PCN	Product Change Notification	De-21-05-0468	
Product	ERmet ZD / ERmet ZDplus	Date of Publication:	
		11.05.2021

**Title:** Modification of the female housing

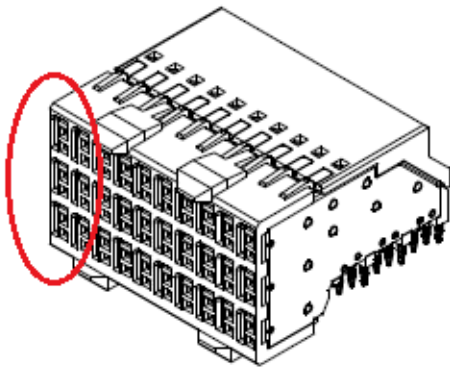
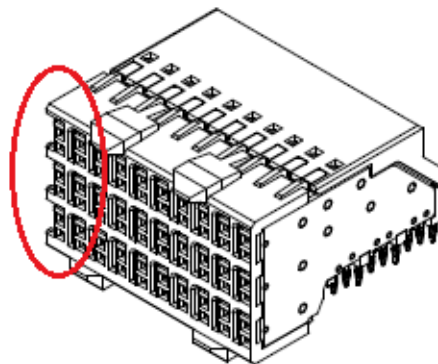
to optimize the manufacturing and handling process of the female ERmet ZD and ERmet ZDplus connectors the geometry of the connector housings has changed. The bars at the mating face have been removed. This change has no influence on the mating behavior.

Parts with the old geometry will be shipped until the existing inventory is exhausted. This change will be operated without part number change.
